H8 Front Panel Fixes:

Les's Z80 CPU Fixes:

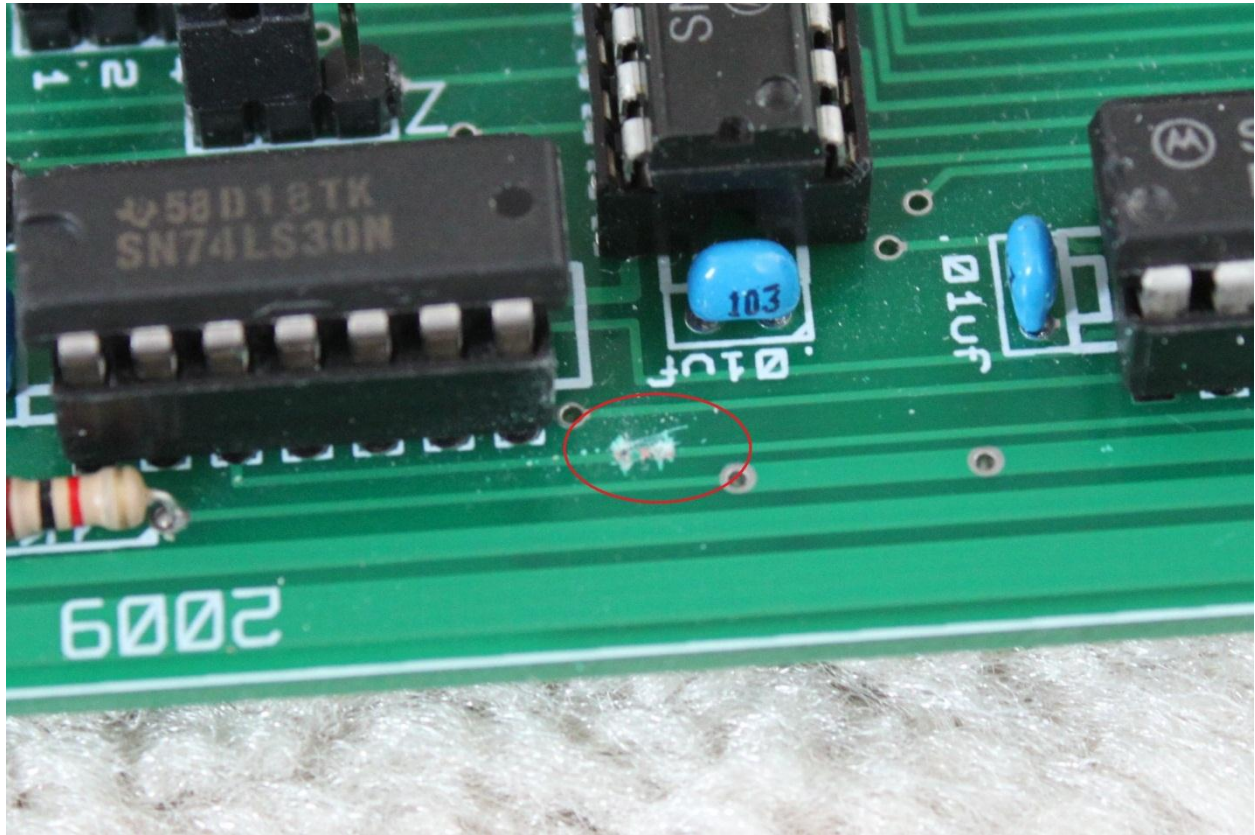
1. Pin 4 on IC105 is floating. Please connect a wire between pin 3 and pin 4 as shown in the diagram. Below is a picture showing the fix.

Please connect a wire between pin 3 and pin 4 as shown (blue wire)

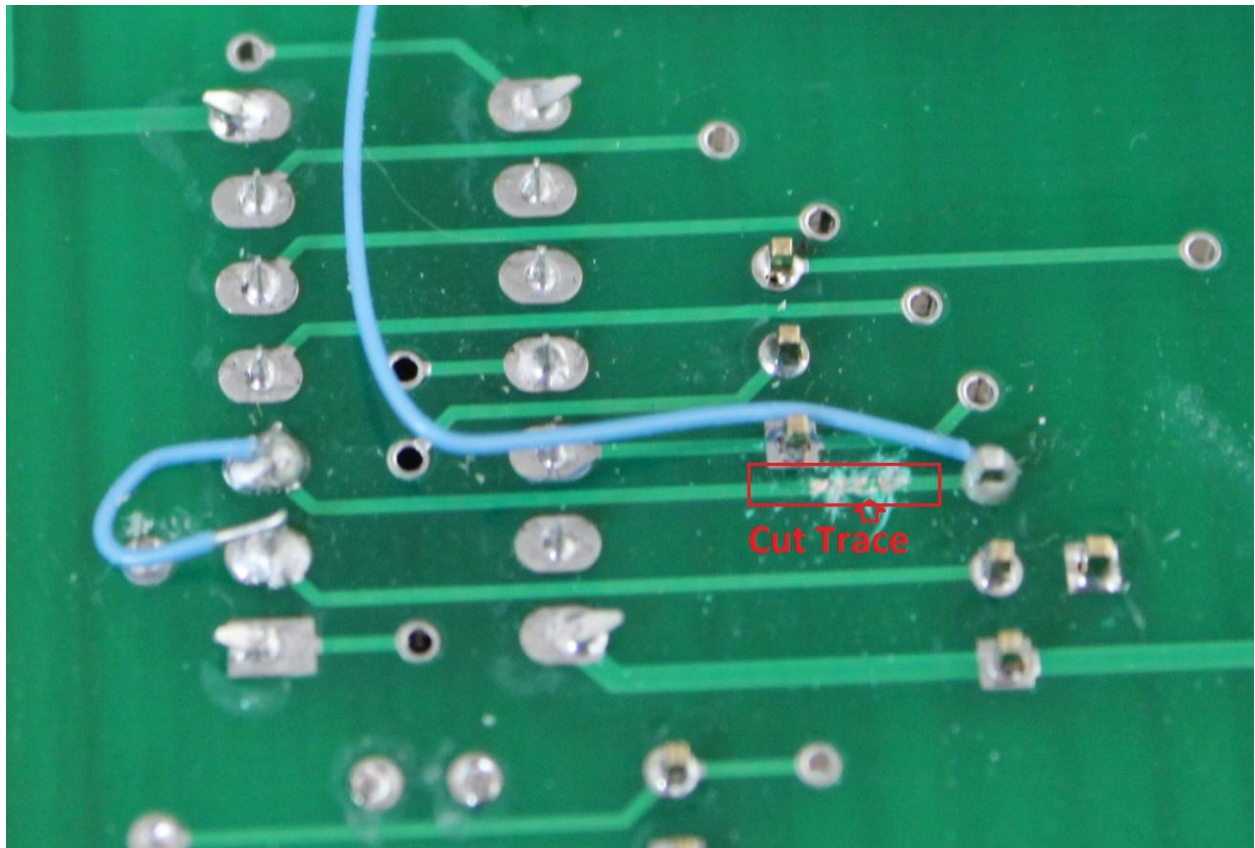
1. Cut the following traces as shown;

Cut trace between U7 pin 3 and U5 pin 3.

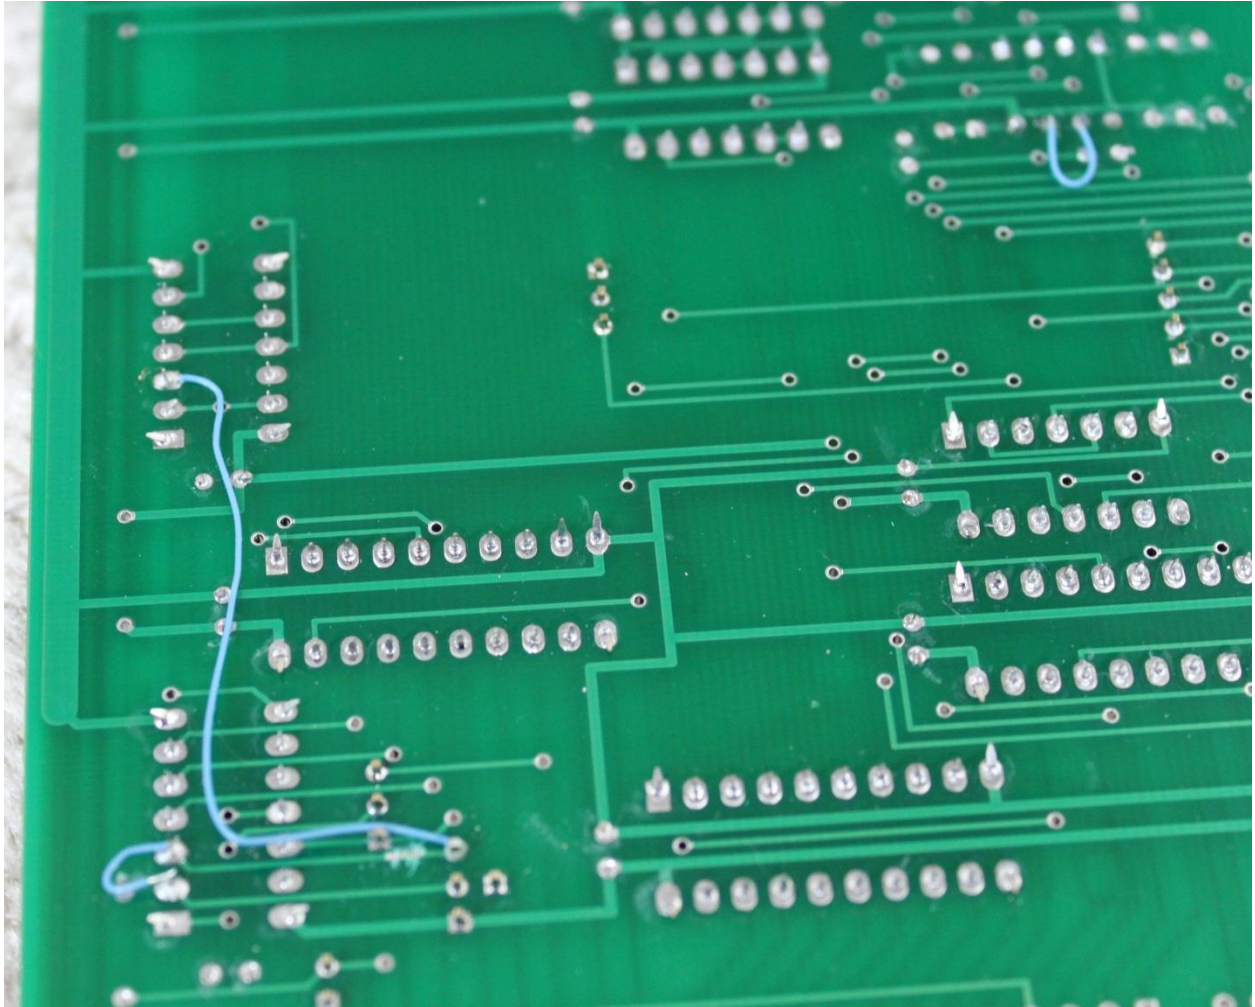
Cut trace between pin 3 of U7 and Y pin 3 header

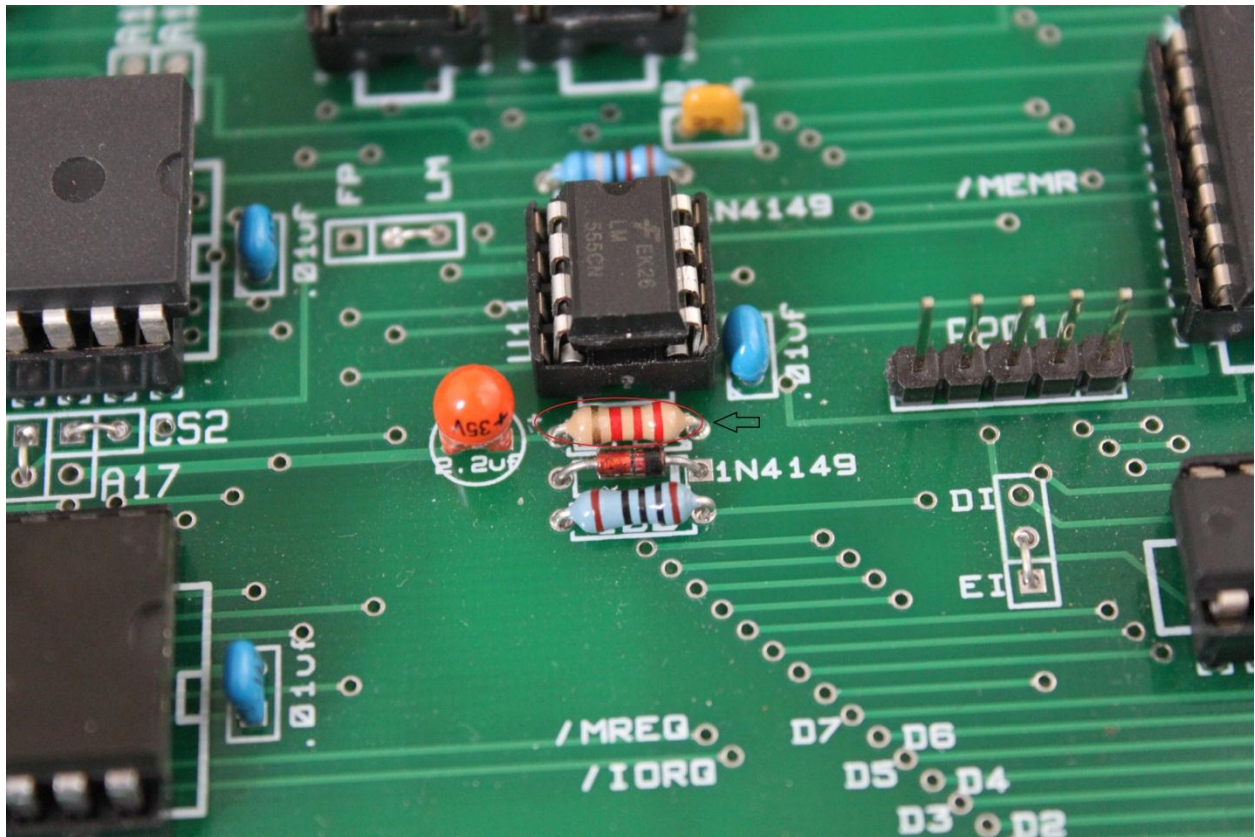
1. Connect a cable from U7 pin 3 and U7 pin 2
2. Connect a cable from Y header pin 3 to U5 pin 3

Reset Circuitry Fixes:

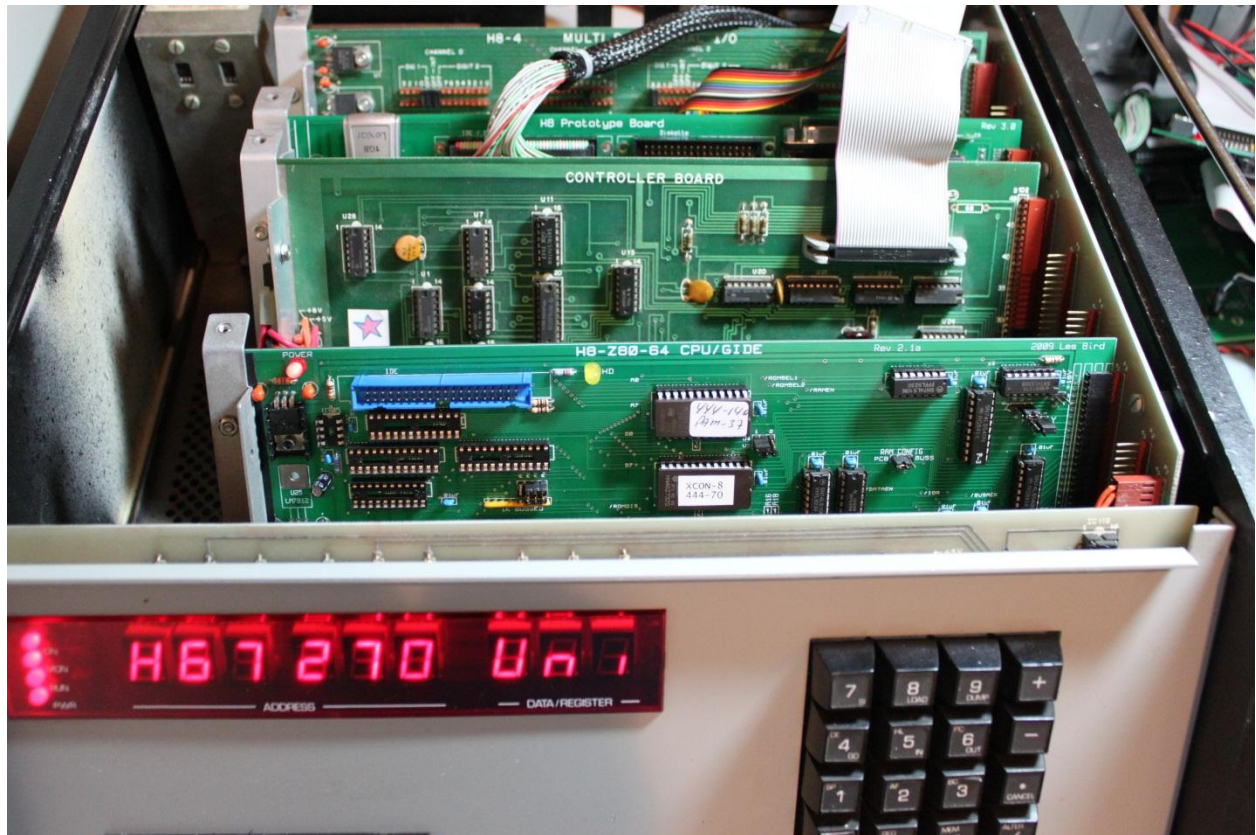
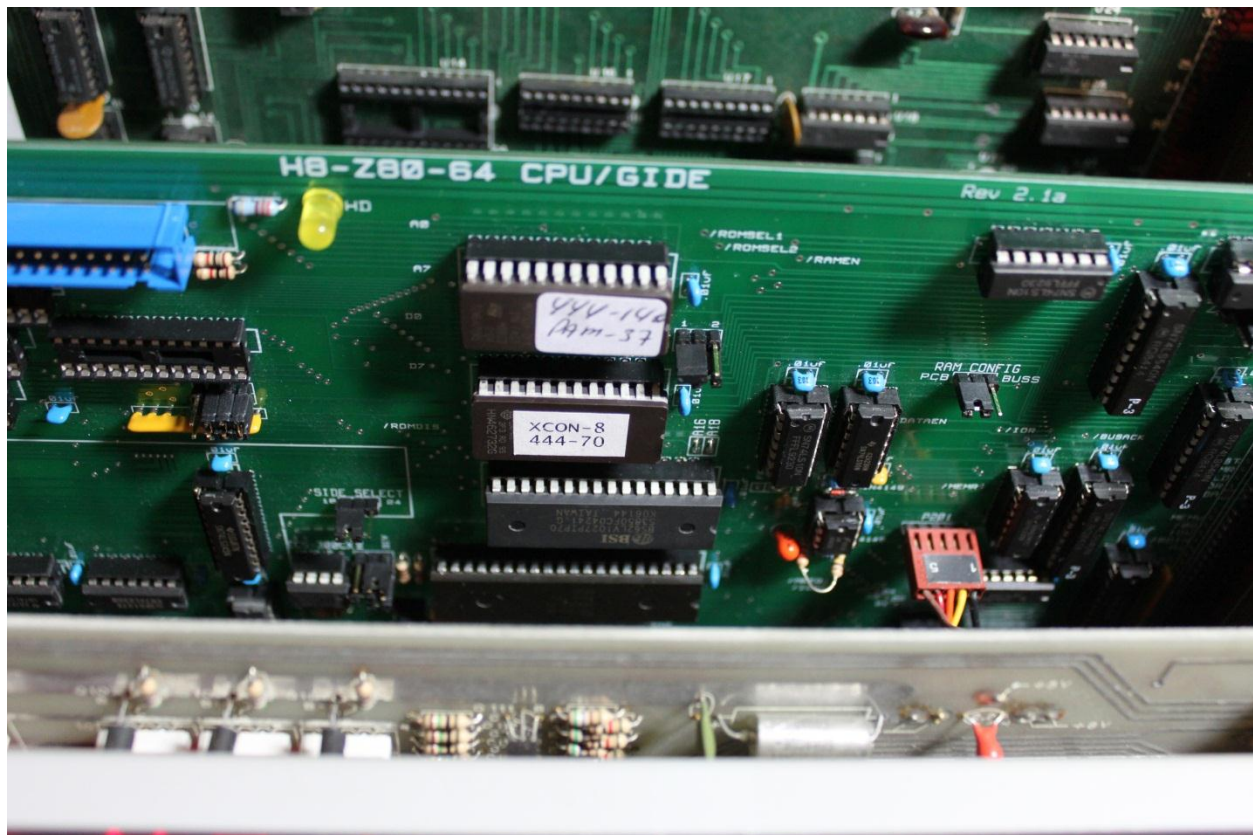
Replace 2.2K resistor with a 470K or a 100K resistor.
